From: Pederson Ronda M (AREVA NP INC) [Ronda.Pederson@areva.com]
Sent: Tuesday, March 31, 2009 8:16 PM
To: Getachew Tesfaye
Cc: BENNETT Kathy A (OFR) (AREVA NP INC); DELANO Karen V (AREVA NP INC); VAN NOY Mark (EXT); HEDRICK Gary E (AFS)
Subject: Response to U.S. EPR Design Certification Application RAI No. 155, Supplement 1
Attachments: RAI 155 Supplement 1 Response US EPR DC.pdf

Subject: Response to U.S. EPR Design Certification Application RAI No. 155, FSAR Ch. 3

QUESTIONS for Structural Engineering Branch 2 (ESBWR/ABWR Projects) (SEB2)

Figure 03.08.01-2-1
Interface Between RBIS and Common Basemat Structure

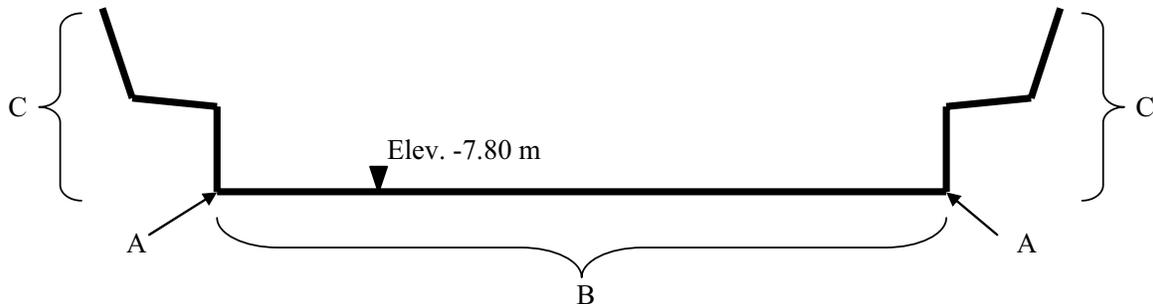
Question 03.08.01-2:

- The nodes around the periphery of the circular base (see Point A in Figure 03.08.01-2-1) were fixed against translation in all three directions. These nodes are free to rotate in all three directions.
- The remaining nodes located on the bottom of the circular base (see Point B in Figure 03.08.01-2-1) were fixed against translation in both lateral directions. These nodes are free to rotate in all three directions, and to translate in the vertical direction.
- The remainder of the nodes along the interface surface (see point C in Figure 03.08.01-2-1) are free to translate and rotate in all directions. This is conservative since these surfaces, if restrained in the model, would provide additional resistance against sliding and overturning.

- The vertical support node (see Point A in Figure 03.08.01-2-1) which carries the largest compressive reaction load is identified. This is the point that the RBIS is trying to overturn about (i.e., the “toe”) for the current loading condition.

Figure 03.08.01-4-1
Jurisdictional Boundaries

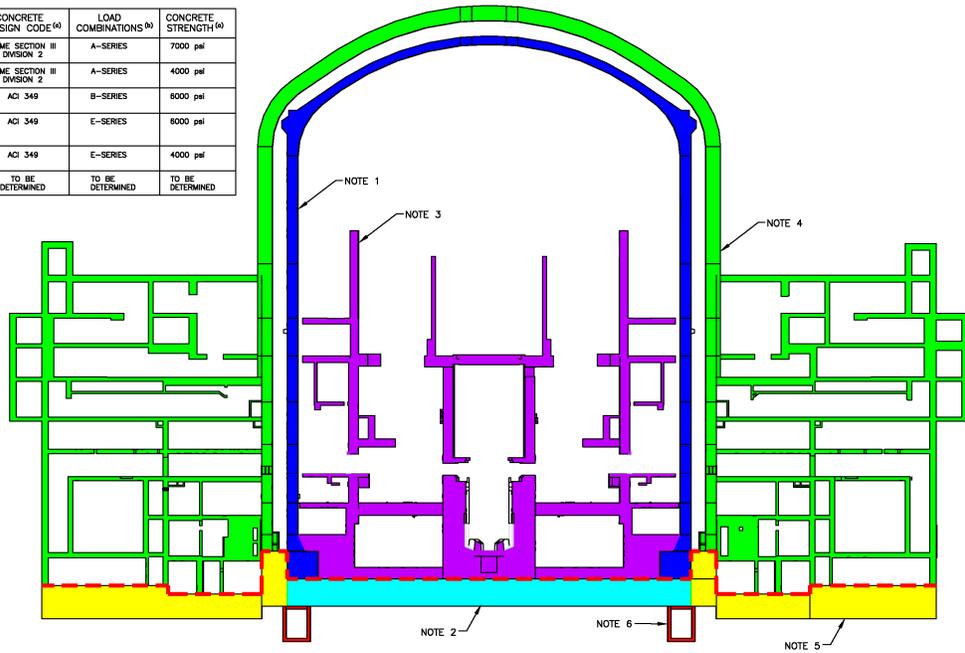
1. Since the RCB is founded on the same NI basemat as several other seismic category I structures, explain where is the ASME containment jurisdictional boundary defined for the EPR plant which must satisfy the code requirements of the ASME Section III, Division 2. The response should consider the fact that the containment basemat is integrally connected to the rest of the NI foundation, and thus additional peripheral volume of concrete and anchorage of the containment shell reinforcement beyond the containment wall should be included in the jurisdictional boundary. In addition, AREVA is requested to confirm that all loads (e.g., wind, lateral earth pressure, etc.) arising from the evaluation of the common basemat outside the rules of ASME Code Section III, Division 2, are considered in combination with those specified for the ASME Code Section III, Division 2 basemat.

1. ASME Section III Division 2 (subarticle CC-1140) does not provide specific guidance on where to locate the jurisdictional boundary between ASME Section III Division 2 and other design codes (i.e., ACI 349). As per ASME Section III Section NCA (subparagraph NCA-3254.2), the jurisdictional boundary shall be specified in the Design Specification. This indicates that the specific location of the jurisdictional boundary is to be determined by the designer. The jurisdictional boundary selected for the U.S. EPR, as applicable to the common basemat, is a cylinder aligned with the outside face of the reactor containment building wall. The complete jurisdictional boundary is shown in Figure 03.08.01-4-1. Together, the turquoise and blue areas form the portions of the common basemat structure under the jurisdiction of ASME Section III Division 2. All loads arising from the evaluation of the common basemat outside the rules of ASME Code Section III, Division 2, are considered in combination with those specified for the ASME Code Section III, Division 2 basemat. For example, when analyzing load combinations for design of the containment

Figure 03.08.03-1-1
Reactor Vessel Support Ring

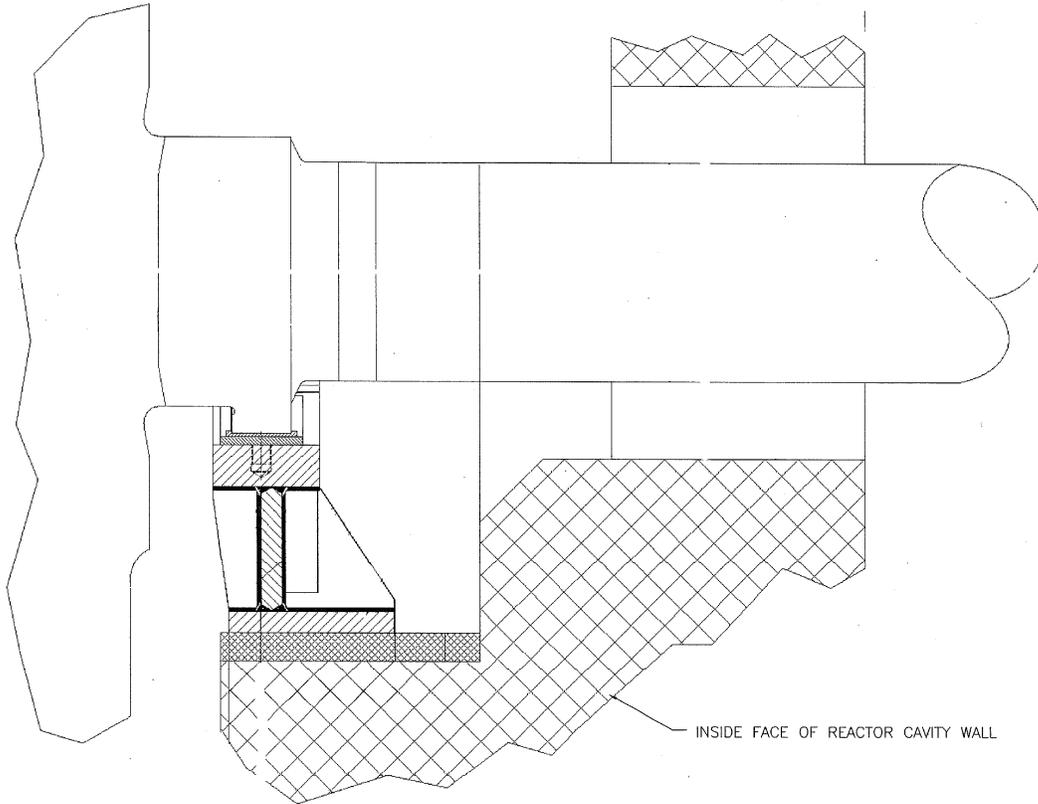
1. Provide additional details which show how the RV ring is embedded into the concrete and the anchorage details.
2. Provide details of the components described in the second paragraph of FSAR Section 3.8.3.1.1 which include the large penetrations in the circular RV support concrete wall, permanently installed cavity seal ring, and neutron shield assembly resting on the embedded ring at the top of the wall.
3. Provide details of the embedment plates, baseplates, grout (if applicable) and anchorages for the RV; vertical and horizontal supports of the steam generators, reactor coolant pumps, and pressurizers; and the polar crane steel plate support brackets.

2. The large penetrations in the circular RPV concrete wall are block-outs that allow the legs of the RCS to pass through. There is a block-out for each leg of the RCS. See Figure 03.08.03-1-1.

Figure 03.08.05-4-1
Seismic Soil Pressure Distribution used in the Design of Foundation Walls

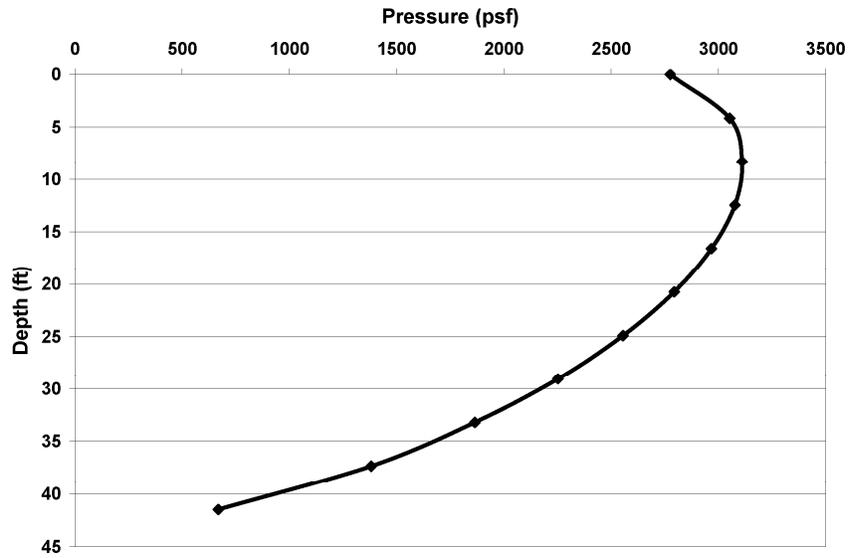
5. If lateral earth pressure loads are needed to resist the structure sliding and overturning, presumably at the same time, provide the seismic pressure distribution used in the design of the foundation walls and compare them to the maximum calculated soil pressure load distribution from the sliding and overturning seismic analysis.

5. Seismic soil pressure used in the design of foundation walls varies with depth with a maximum of 3.11 ksf (see Figure 03.08.05-4-1 for pressure distribution). Maximum bearing pressure from seismic sliding analysis is 34.56 ksf (see Figure 03.08.05-4-2 for bearing pressure distribution under sliding event).

Figure 03.08.05-17-1
Emergency Power Generating Building Reinforcement

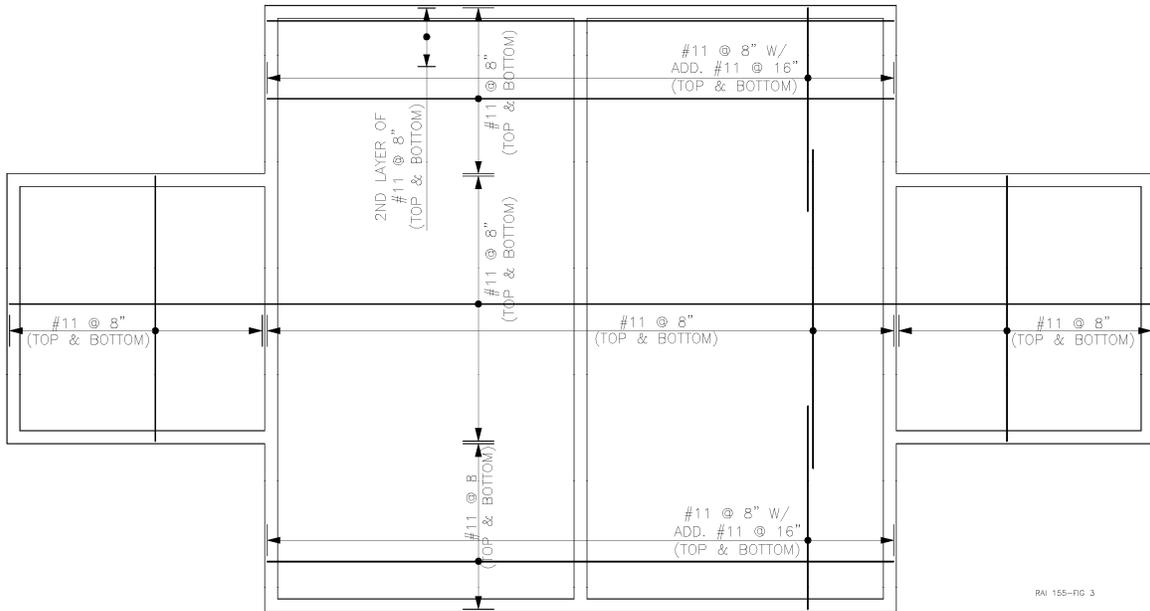
FSAR Section 3E.2.1 for the EPGB foundations and FSAR Section 3E.3.1 for the ESWB foundations describe the basemat typical reinforcement configurations in FSAR Figures 3E.2-3 and 3E.3-3, respectively. These figures indicate the horizontal reinforcement pattern for each foundation design, but do not indicate whether this reinforcement is in the top or bottom of the slab. Provide additional figures showing key cross sections of the slabs that indicate the size, location and spacing of the top and bottom reinforcement, as well as any vertical reinforcement. Also, please reconcile the difference in the reinforcement for the NI foundation specified in FSAR Table 3E.1-37 and shown in FSAR Figure 3E.1-75.

The reinforcement shown in U.S. EPR FSAR Tier 2, Figures 3E.2-3 and 3E.3-3, is required on both top and bottom faces. The information provided in the U.S. EPR FSAR is limited due to scale. The specific requested detail is provided in Figures 03.08.05-17-1 through 03.08.05-17-4.
